RUTHERFORD AVENUE 25% DESIGN PHASE: URBAN DESIGN  
Sullivan Square - Current Layout

January 24, 2018

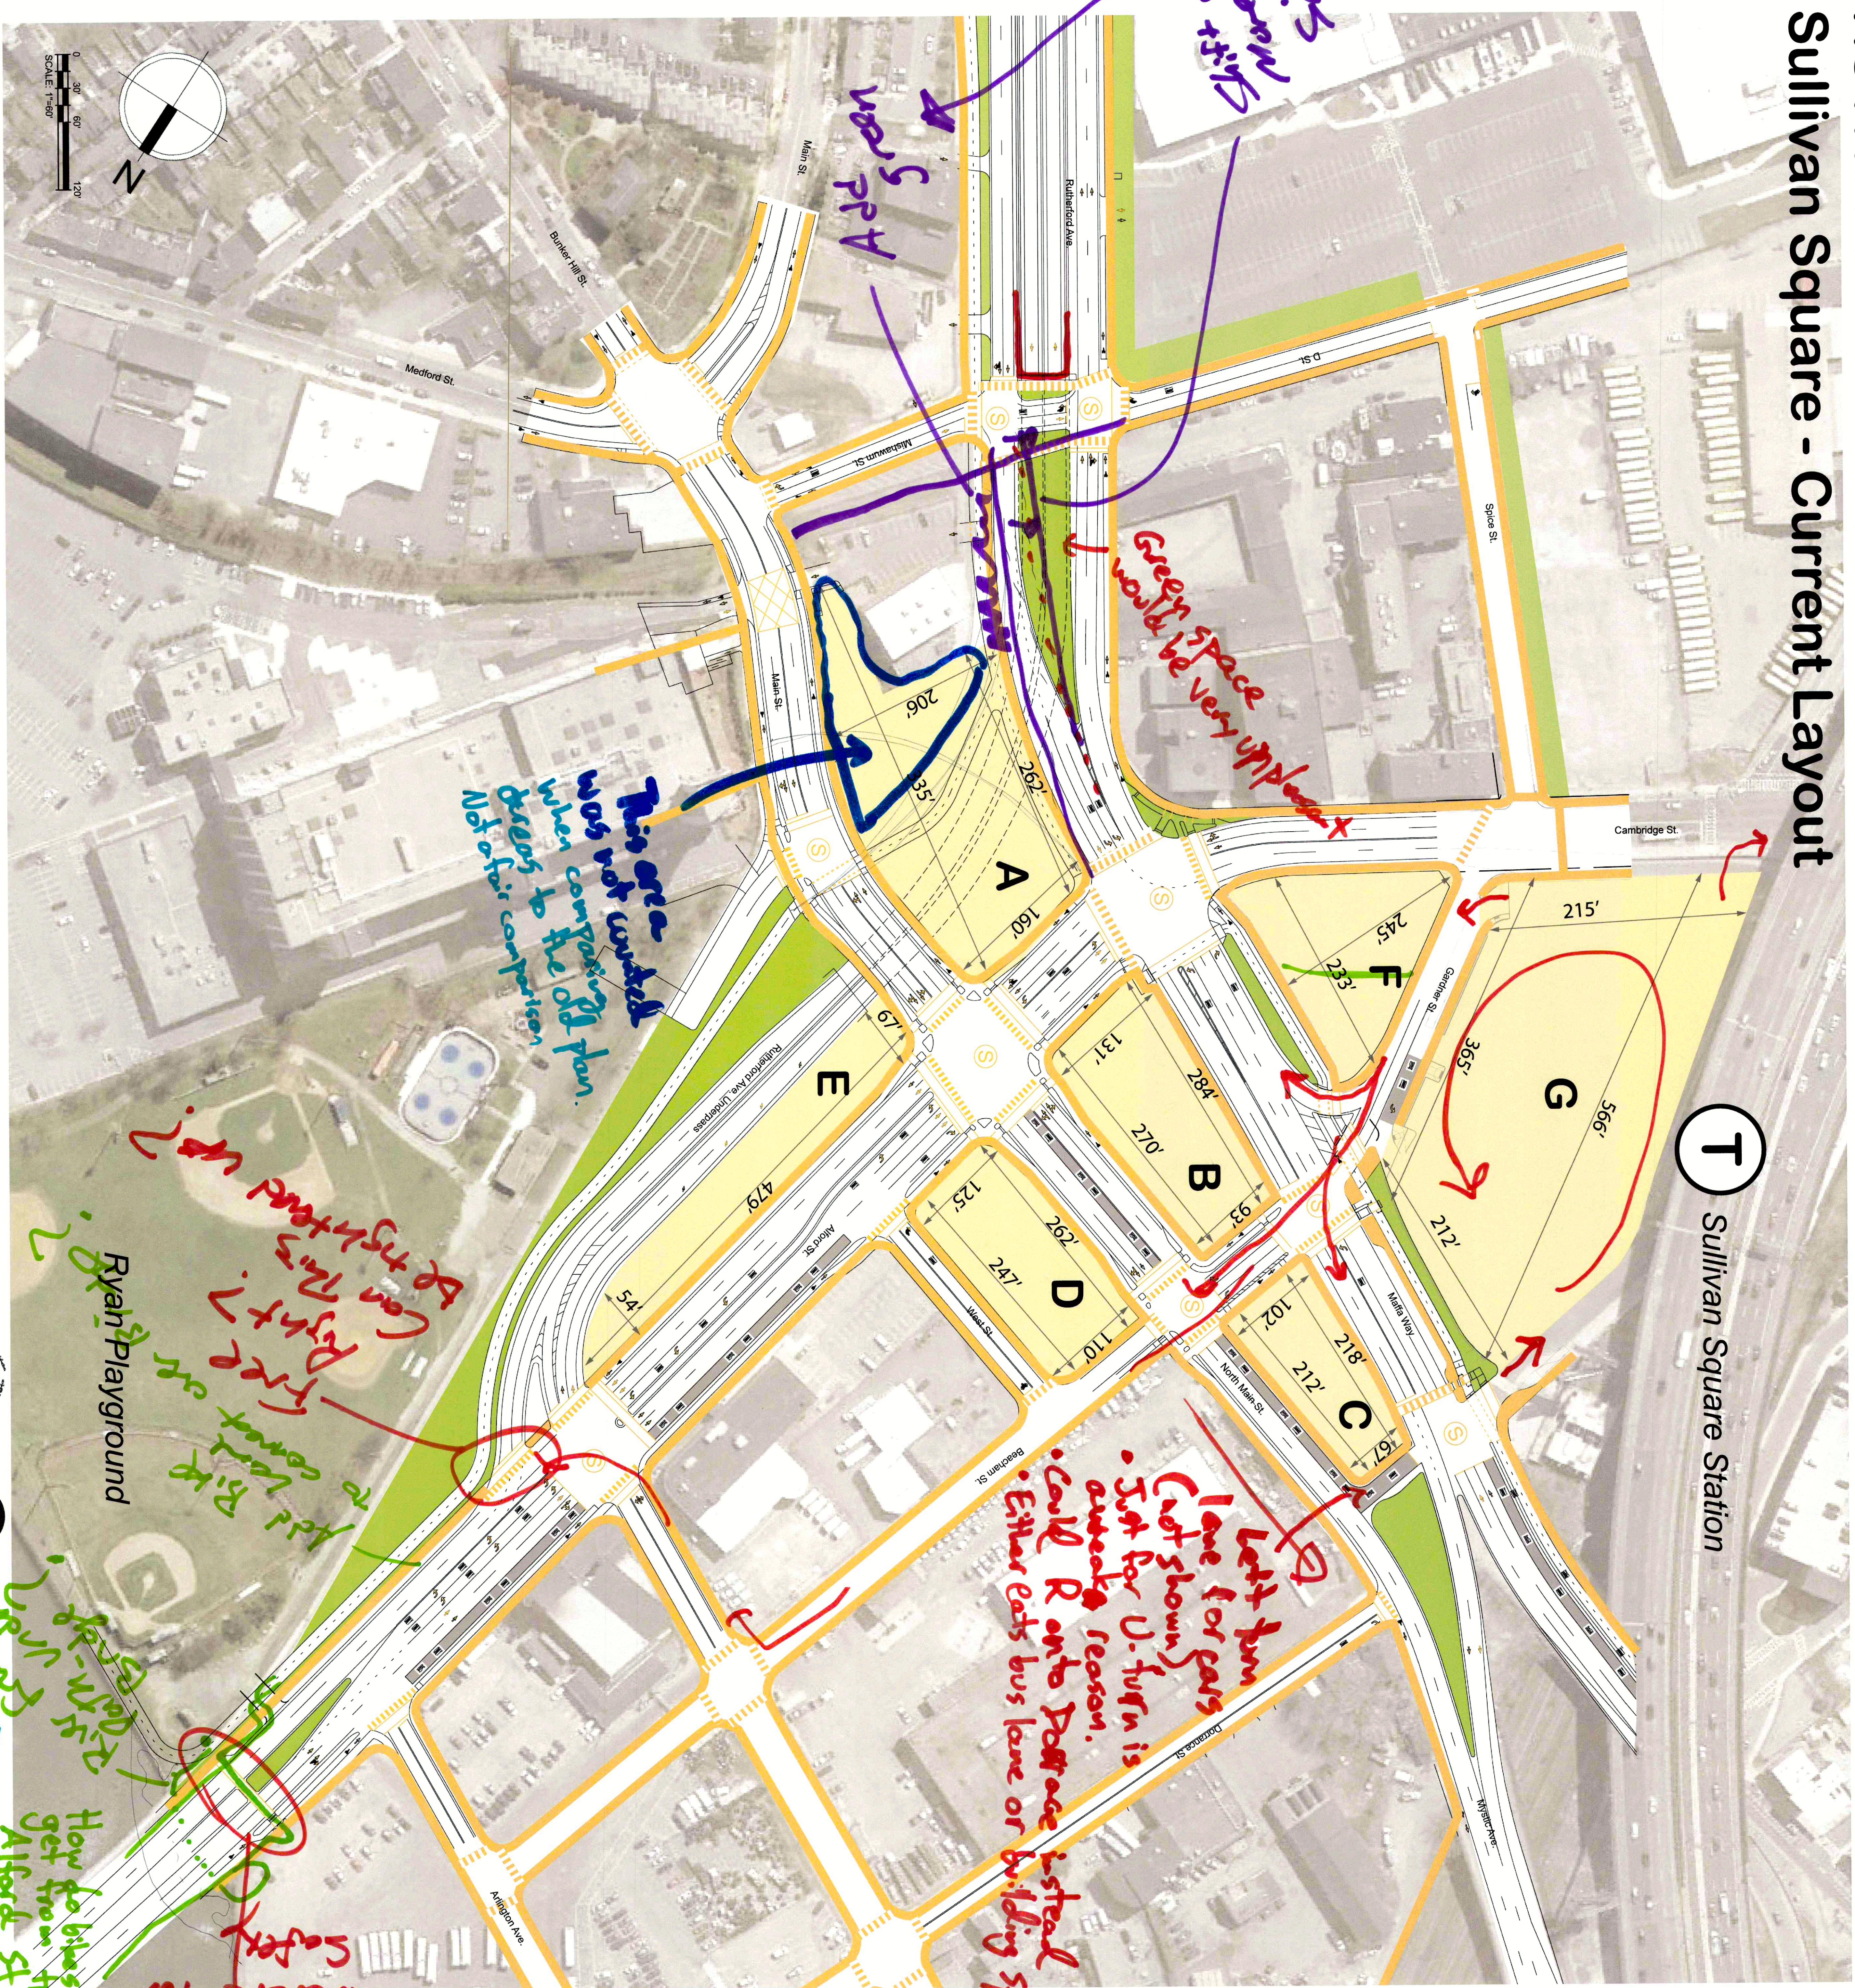
-BASE SUBJECT OF  
PROJECT SHOULD INCLUDE  
RECKONING OVER PARCELS  
DEV. AREAS, ie PARK  
US AREAS, ie PARK

-IF METRA LIND GETS ACQUIRED  
TO DEVELOP RAILWAY/MARK  
S BUS/COMMUTER RAIL FACILITY  
NEEDED MAINTENANCE  
-IF PAYING TO REPAIR RAIL CAR  
GARD & BE OPEN TO RECONSTRUCT  
IT FOR EFFICIENT RAIL ROUTE

Green space  
would be very important

This area  
was not included  
when comparing  
plans to the old plan.  
Not a fair comparison

Left turn  
lane for cars  
(not shown)  
Just for U-turn is  
adequate reason.  
Could R onto Post road instead  
• Either eats bus lane or building space

Can Ryan  
Be right hand way?  
Ryan Playground  
Fire  
Can Ryan  
Be right hand way?  
Ryan Playground

Signal for  
Safety  
Needed for  
Signal for  
Safety  
Needed for

How do bikes  
get from trail to  
Alford St bridge  
Maybe turn HAWK into  
a real signal, so Southbound  
bikes can cross to the trail?
